August 1, 2018

**Subject: Geotechnical opinions of south and north bank fish ladder construction options at Scott Dam**

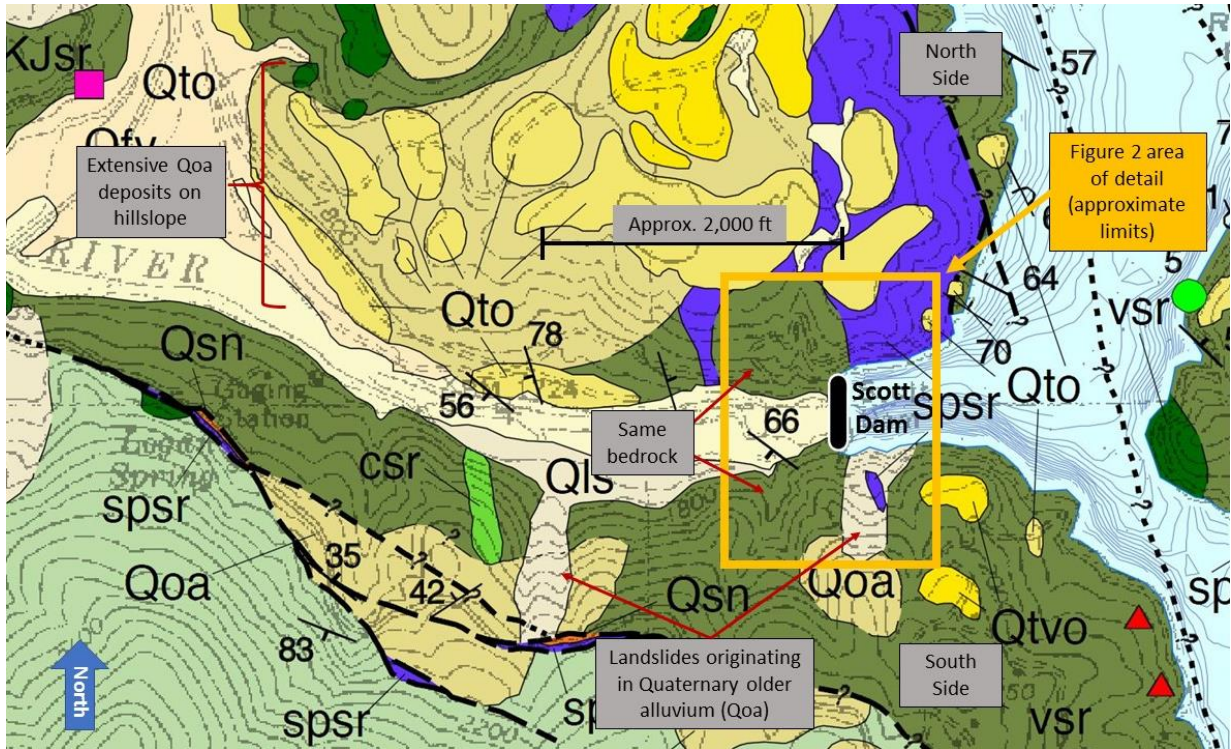
Ohlin et al. (2010) show three large landslides on the south bank, all having originated in older alluvial deposits, which suggests that the alluvial deposits are susceptible to mass wasting (Figure 1). As part of a more detailed site-specific investigation, PG&E (2016) summarize the geology and geomorphology at Scott Dam, both in the immediate up- and downstream vicinity. Their mapping is at a much higher resolution than Ohlin et al. (2010), and shows additional earthflows, slumps, and debris flows on both the north and south bank (Figure 2). The most attention in their report has been given to the large landslide complex located on the south bank adjacent to the left bank dam abutment (called the “1920 slide”, this is one of the three slides also mapped by Ohlin et al. 2010; see PG&E 2016 for additional detail and discussion of historic mapping, monitoring, and related analyses). The PG&E investigation is focused primarily on the south bank and contains limited mapping and description of the north bank, yet the north bank mapping identifies three headscarps (topographic features showing displacement resulting from past landslide activity) showing some mass wasting features on this bank as well (Figure 2).

Although more mass movements have been documented on the south bank (in part due to more detailed mapping and investigation focusing on the south bank), the north bank consists of a substantially larger area of alluvial deposits, suggesting that overall there may be a higher risk for future hillslope failure on the north side of the channel (thereby also suggesting the south side is a more suitable location for constructing a fish ladder); however, much of the mapping on the north side of the channel did not include mass movement activity type (e.g., slump, slide, or flow) or activity status (e.g., active, dormant, relict). Additional investigations are recommended to better identify the location and type and activity of landslide (or other mass movement) features which could affect future fish passage facilities at the site, such as aerial photograph and LiDAR review, and geomorphic mapping to better identify, map, and assess the activity of geohazards on both the north and south banks. The results of this investigation can better inform fish passage facility design (e.g., wrap-around fish ladder with shorter hillslope traverse compared to straight ladder with longer hillslope traverse) to help minimize areas of unstable (or potentially unstable) ground.
